SUBJECT: EXPANDED OPERATING DOMAIN (ARTS/MELLLA) TECHNICAL SPECIFICATIONS,  
PEACH BOTTOM ATOMIC POWER STATION, UNIT 2 (TAC NO. M86132)

PEACH BOTTOM ATOMIC POWER STATION, UNIT NO. 2

AMENDMENT TO FACILITY OPERATING LICENSE

Amendment No. 192  
License No. DPR-44

Figure 1.1-1

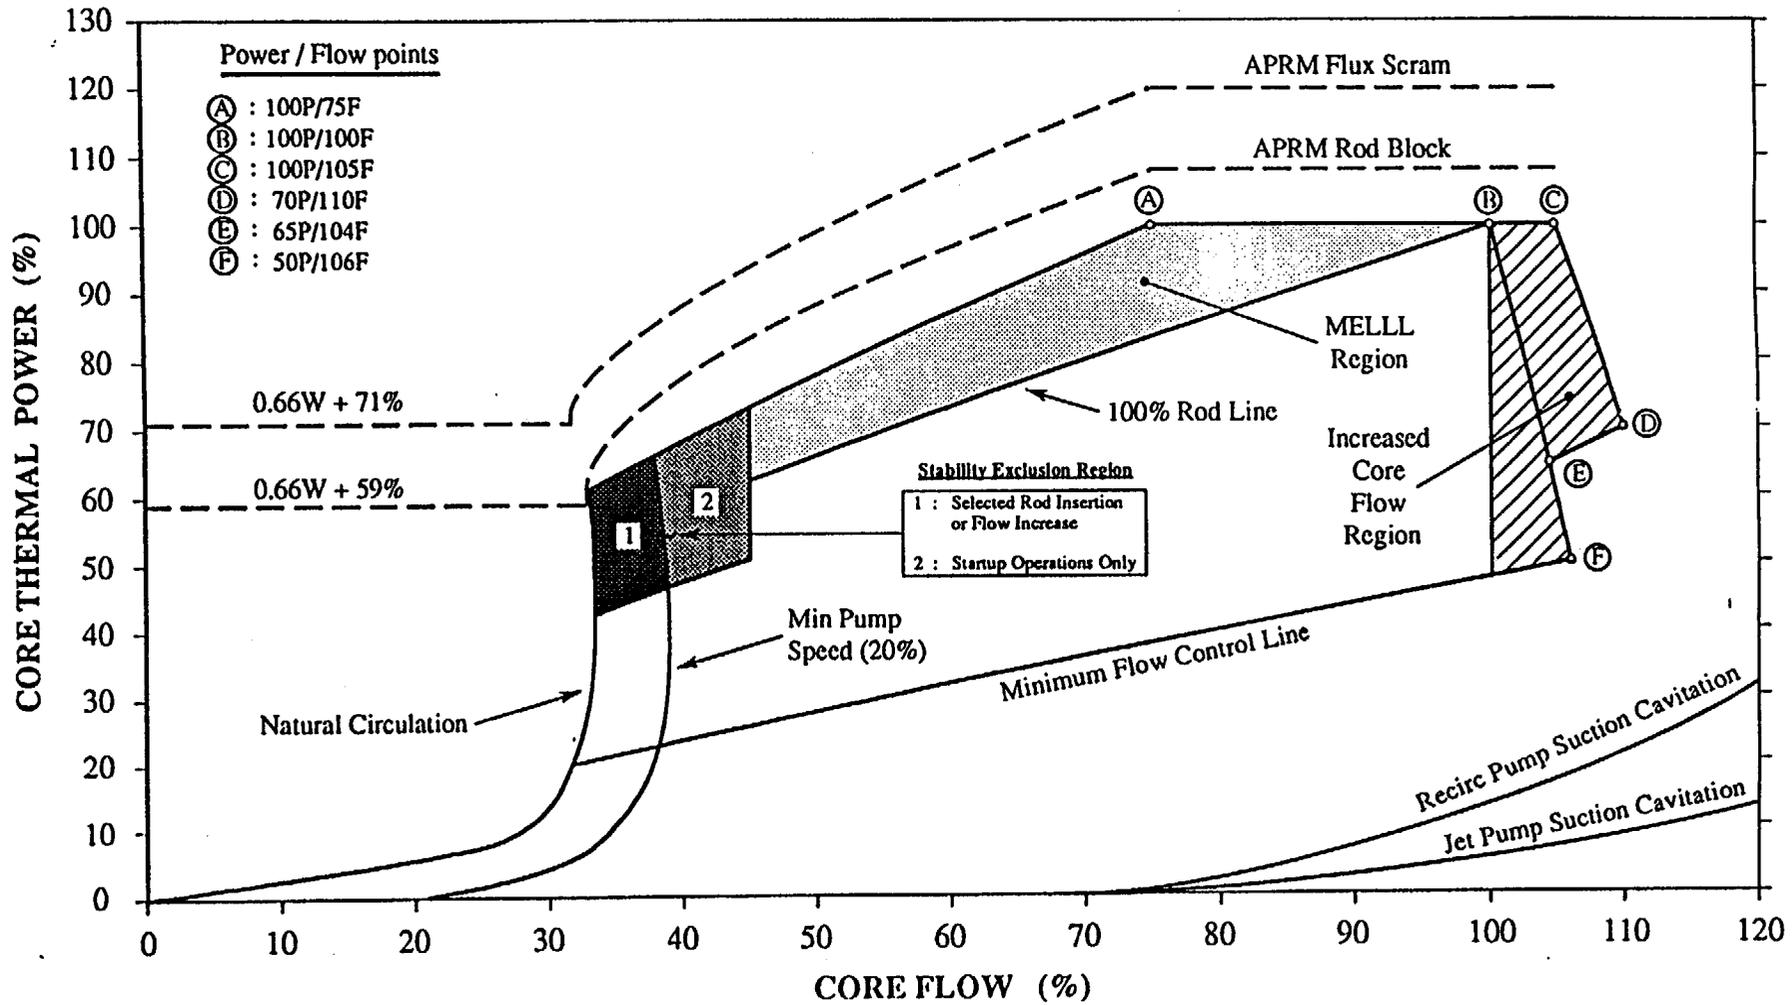
- c. The Safety Limit Bases Section 1.1 References are updated to include the GE ARTS/MELLLA analysis report (Reference 3).
- d. Figure 1.1-1, entitled, "APRM Flow Bias Scram Relationship to Normal Operating Conditions," (the power-to-flow operating map) is revised to include the MELLLA region and the updated APRM limits. This revision is acceptable based on the discussion in Section 2.1.2 of this evaluation.
